TOPOGRAPHIC SURVEY
MIKE SACHAR
18009 SE 40TH PLACE
BELLEVUE, WA 98008

NELSON DRIVEWAY
 18009 SOUTHEAST 40TH PLACE

DRAINAGE, GRADING, & UTILITY PLAN

FIGURE 1: EXISTING CONDITIONS
NELSON PROPERTY - STEEP SLOPE MITIGATION PLAN
18009 SE 40TH PL.
BELLEVUE, WA 98008
PARCEL 1824069182

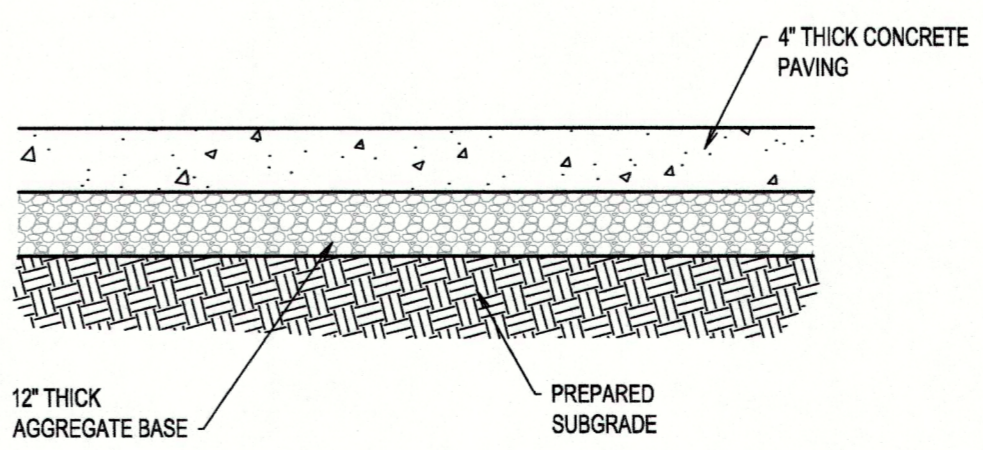
In order to be approved to connect to this storm CB.
 1. Show all of the road ROW or lot lines
 2. Show any storm easements/ utility easements that are in that area
 3. Show much more of the storm system to the East. we don't show any of that system on our GIS maps.
